Pennsylvania Power & Light Company

MAR 13 1992

**SUSQUEHANNA STEAM ELECTRIC STATION
RESPONSE TO STATION BLACKOUT SAFETY EVALUATION
PLA-3745 FILE R41-2**

**STATION BLACKOUT RULE
RESPONSE TO NRC SAFETY EVALUATION**

Figure 1

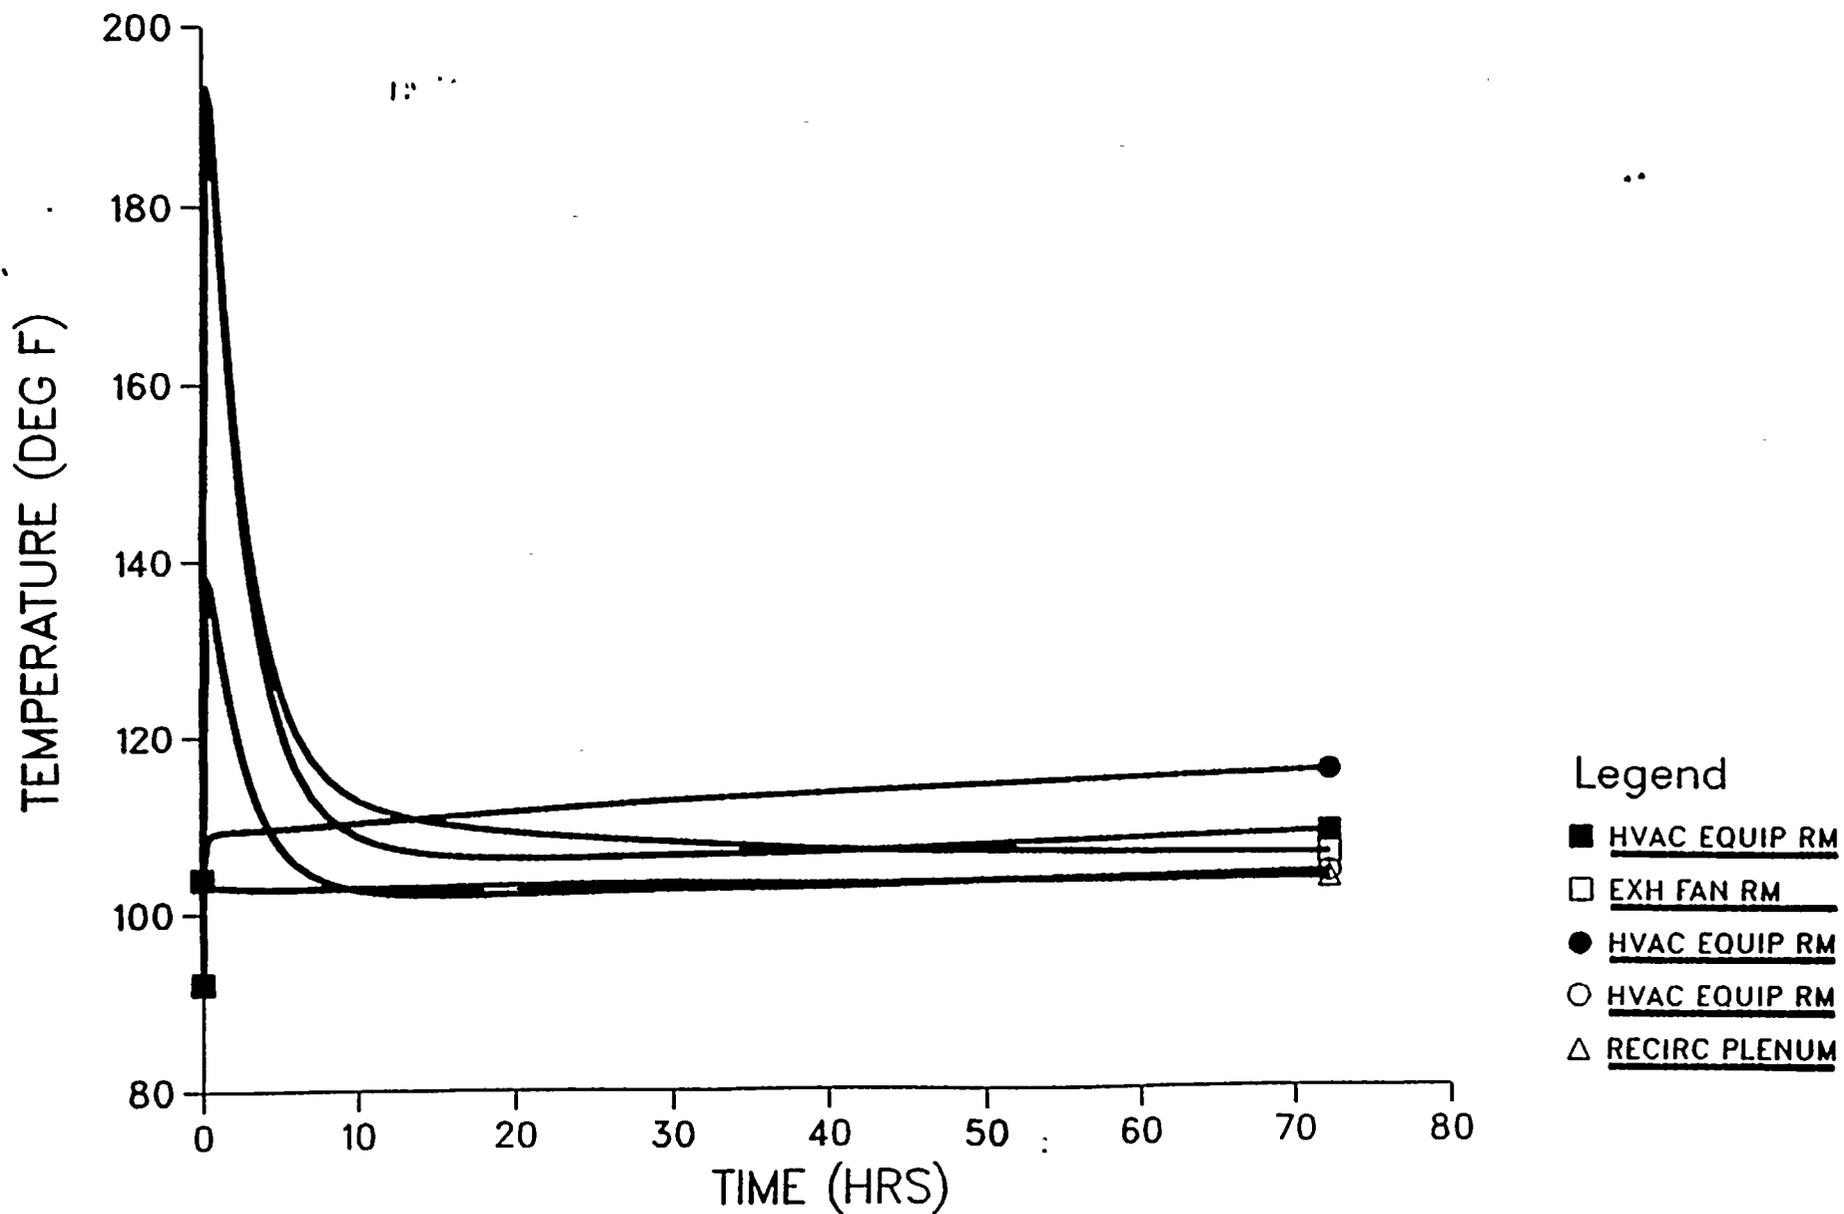
The licensee should: 1) provide additional information and/or technical justification for the initial conditions and assumptions used in the heat-up analysis for each area of concern, 2) with regard to COTTAP computer code, provide detailed information to address the staff's concerns as identified above, and 3) re-perform the heat-up analysis for each area of concern and for an 8 hour coping duration taking into account the non-conservatism as identified in the SAIC TER.

The TER made reference to "oscillatory" temperature profiles. Review of the original COTTAP2 work revealed no such profiles. The reviewers may be referring to temperature profiles which peak and drop in the short term, then continue a long term temperature rise (Figure 1). The large early peak is caused by AC motor heat loads which decay away. At later times, the room is heated by surrounding walls. This result is consistent with expected behavior.

PP&L RESPONSE - COTTAP2 Calculations

PP&L recalculated the DAC temperatures using COTTAP2 and "conservative" inputs. Inputs included use of "maximum normal" room temperatures per the FSAR. Outside air temperature was assumed to be a constant 95°F. The influence of hot piping (including flued heads) was added to the HPCI, RCIC, RHR piping area, and the main steam tunnel. (The absence of this hot pipe loading caused the cooldown of the main steam tunnel noted in the SAIC Technical Evaluation Report). No engineering reference for a concrete thermal conductivity of 0.7 could be found. However, this value was changed from 1.0 to 0.7 per the TER. The actual input deck, and the justification for all input values used, appears in the detailed calculation.

From Table 3, the temperatures of the DACs remain less than the 180°F operability limit, even at 72 hours. The inclusion of the hot pipe loads does cause significant increases in tunnel temperatures.
